## ADDENDUM #1

Reference: Losee Center Remodel  
Utah Valley University – Orem, Utah  
DFCM Project No. 07196790

## ADDENDUM - 2

Project: UVU Losee Center Remodel  
DFCM Project Number: 07196790  
Axis Project Number: 0719  
To: Mike Ambre  
From: Axis Architects  
Date: August 8, 2008

EXITING PLAN

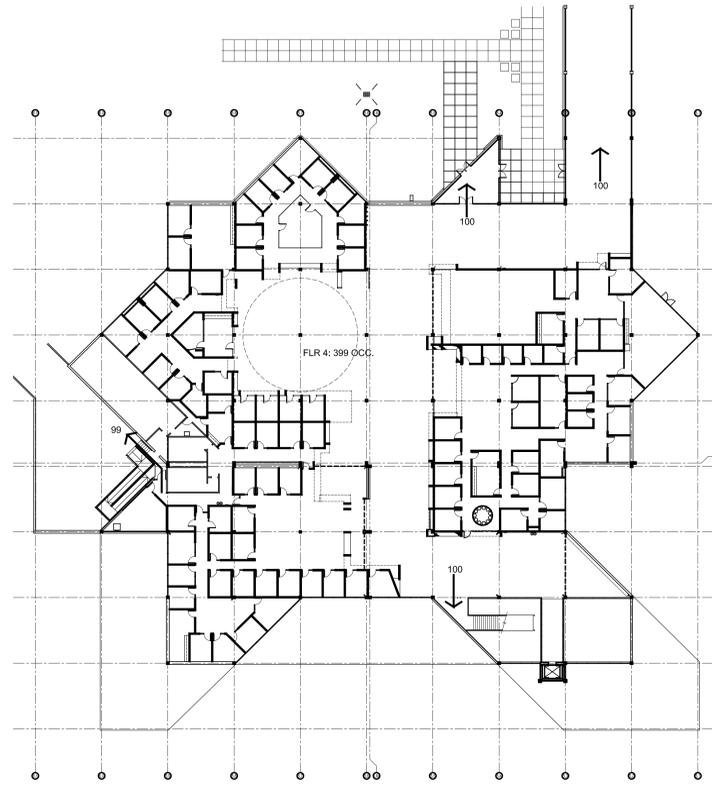
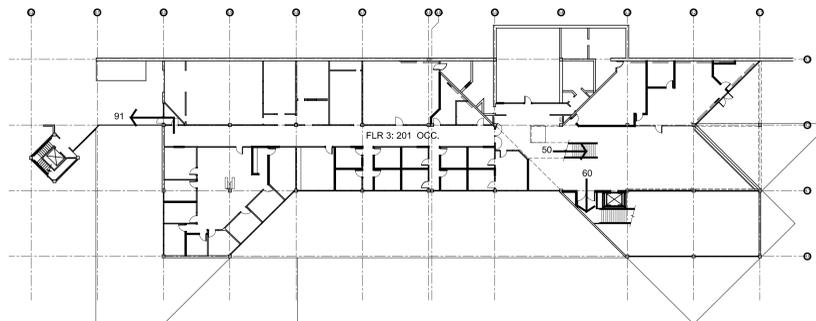
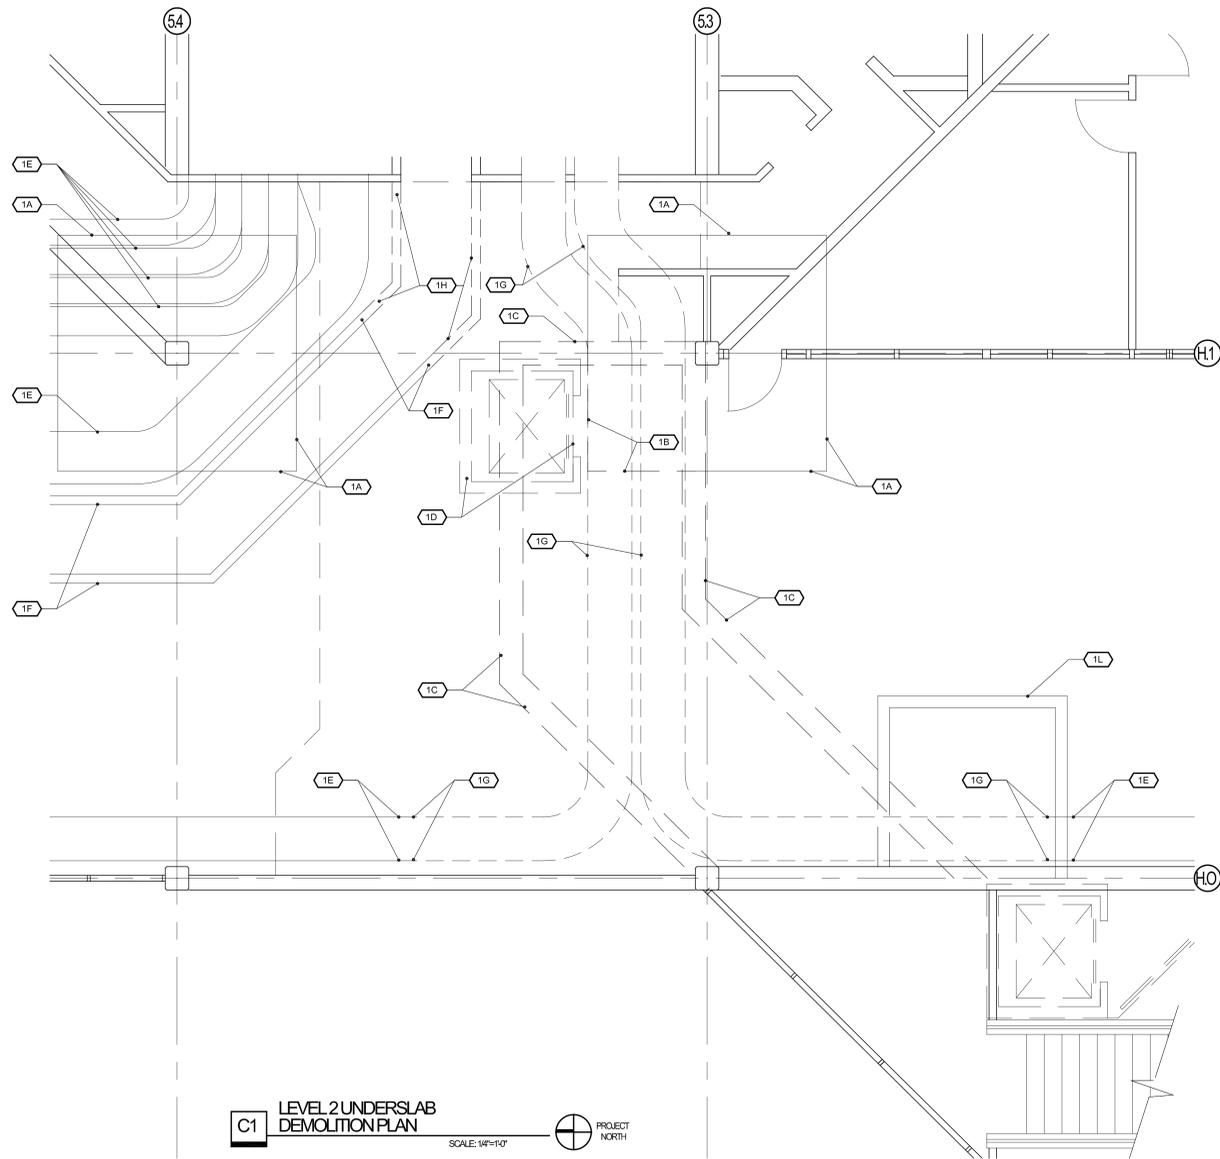
- 2.1** Add the Attached Drawing Sheet G1102
- 2.2** Add the Attached Drawing Sheet AE001
- 2.3** Add the Attached Drawing Sheet AE102A
